SERVICE INSTRUCTION

Number: 771-1886

New wheel bolt

Saab 9-5 from M98.

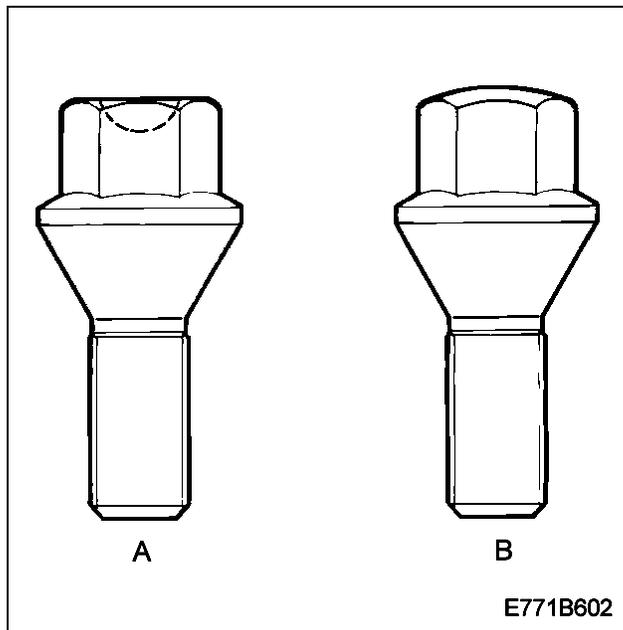
A new wheel bolt (**B**) with another surface coating has been introduced in production. This bolt has a higher friction than the bolt used earlier (**A**), which results in an increasingly stable tightening torque.

The tightening torque for the new bolt (**B**) is the same for both steel wheels and light alloy wheels.

Tightening torque 120 Nm (88.8 lbf ft)

49 08 067 New wheel bolt (CA: 30570431)
